AGENDA – Planning Commission Meeting

Site Plan
Pony Express Dental
February 13, 2020
Public Meeting

Author: Gordon Miner, City Engineer
Subject: Pony Express Dental Office – Site Plan
Date: February 13, 2020
Type of Item: Site Plan Approval

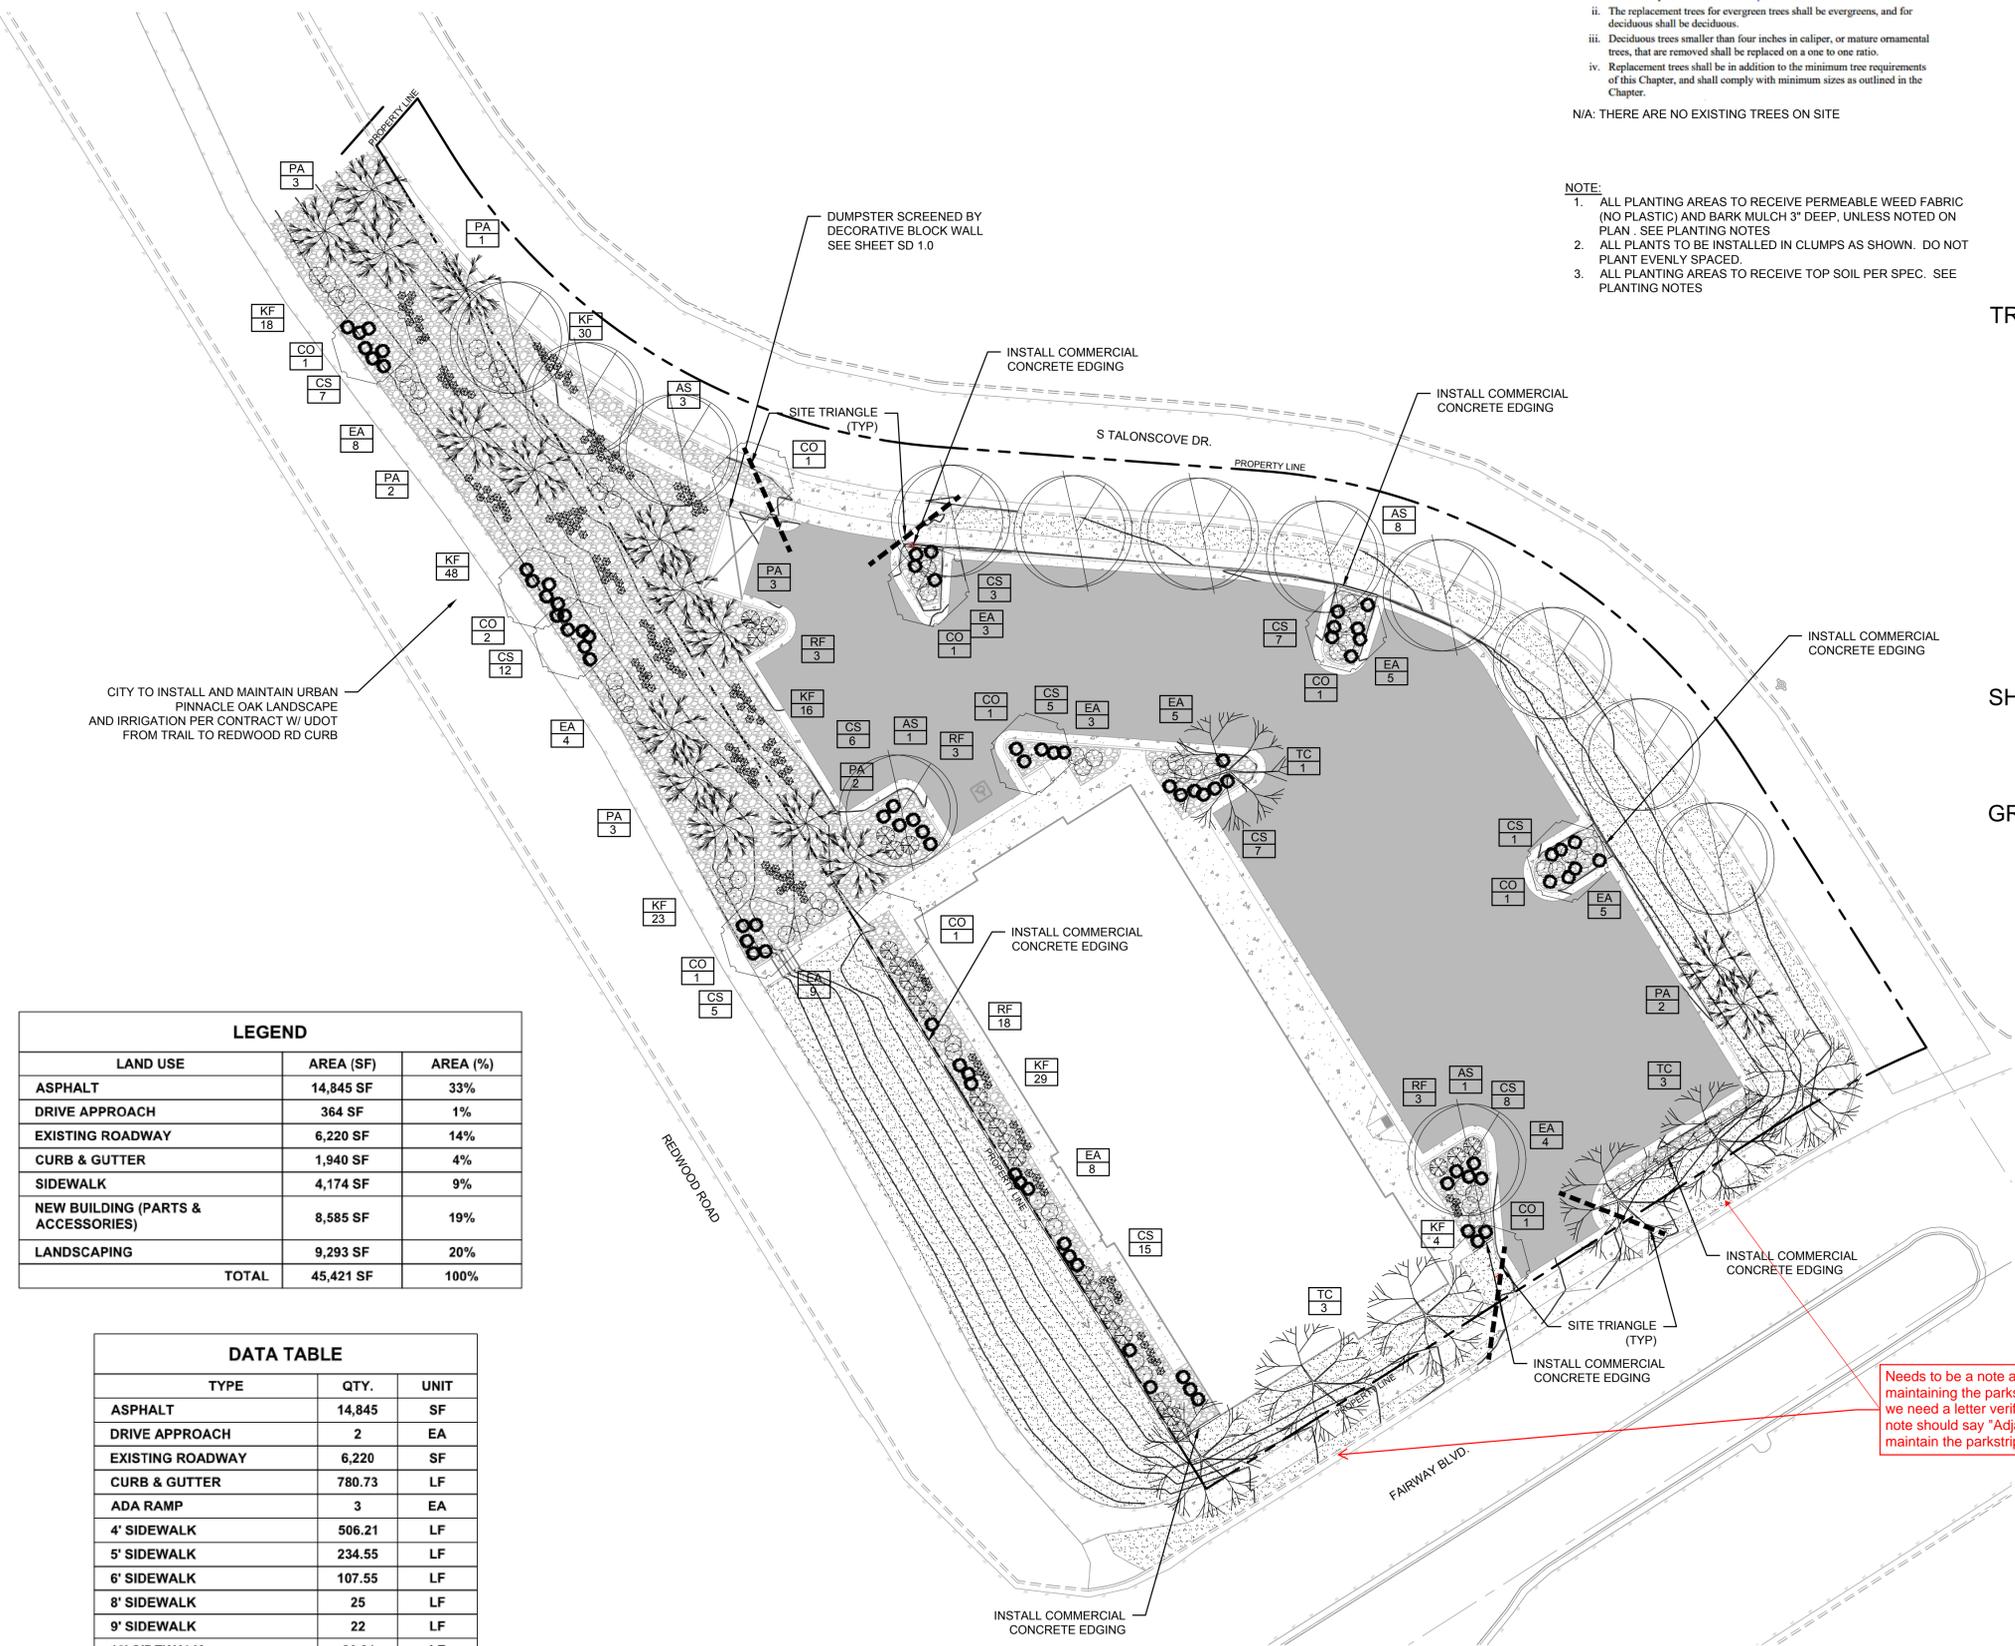
Needs to be a note about who is maintaining the parkstrips. If it is the HOA, we need a letter verifying this. If not, the note should say "Adjacent property owner to maintain the parkstrip."
